UNITED STATES DEPARTMENT OF COMMERCE  
National Oceanic and Atmospheric Administration  
NATIONAL MARINE FISHERIES SERVICE  
GREATER ATLANTIC REGIONAL FISHERIES OFFICE  
55 Great Republic Drive  
Gloucester, MA 01930-2276

Re: Cape Wind Energy Project, Facilities Design Report and Fabrication and Installation Report (FDR/FIR) and revised Construction and Operations Plan (COP)

Figure 1. Inner Array Cable Route (provided by BOEM)

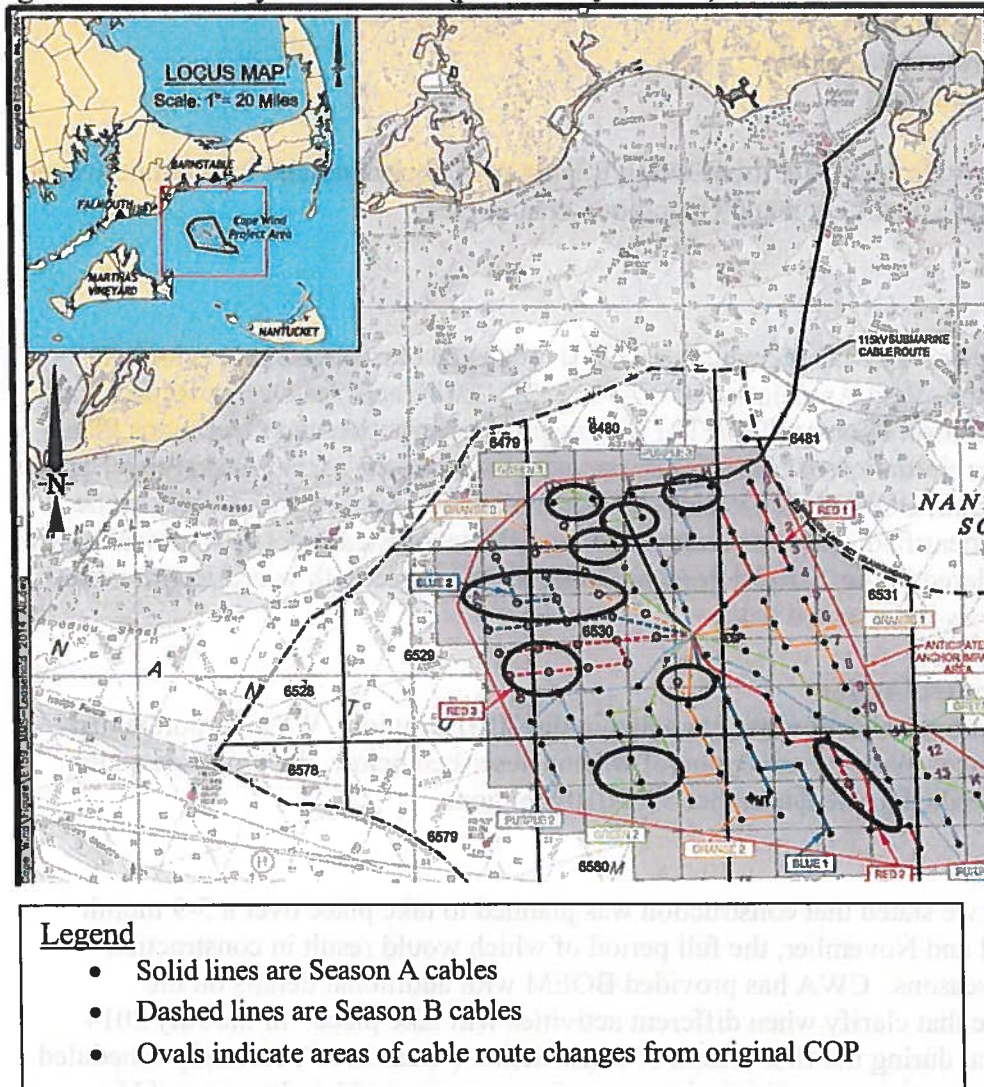
CWA has made minor modifications to the inner array cable routing. In addition, the total length of the cable route is increased to 70 miles from 66.7 miles, an increase of approximately 3.3 miles. The inner array cable route is illustrated in Figure 1. As illustrated in Figure 1, cable installation will occur in two construction seasons.

In the 2010 Opinion, we considered the effects of installation and maintenance of 66.7 miles of submarine cable. CWA is now proposing to install approximately 70 miles of cable, an increase of about 3.3 miles (5%). No changes to the installation methodology are proposed. Effects considered in the Opinion included: the potential for interactions with the cable laying equipment; temporary loss of benthic resources for foraging sea turtles; exposure to increased turbidity and suspended contaminants; and exposure to the cable's electromagnetic field (EMF). It is important to note that the 3.3 miles of additional cable will occur in the same locations we considered for installation of cable in the 2010 Opinion. In the 2010 Opinion, we considered effects of installation of the cable via jetplow. We analyzed the potential for interactions with the cable laying equipment as well as the effects of destruction of prey, loss of benthic resources, turbidity, suspended sediments and exposure to the cable's electromagnetic field. We concluded that all effects of cable installation to listed whales and sea turtles would be insignificant and discountable. The small increase in the amount of cable to be installed does not introduce any new effects that were not considered in the 2010 Opinion. The effects previously analyzed would also occur over the extra 3.3 miles. However, given the installation methodology and habitat characteristics are the same for the extra 3.3 miles of cable, we expect the additional effects would also be insignificant and discountable as would the aggregate effects of laying the full 70 miles of cable.
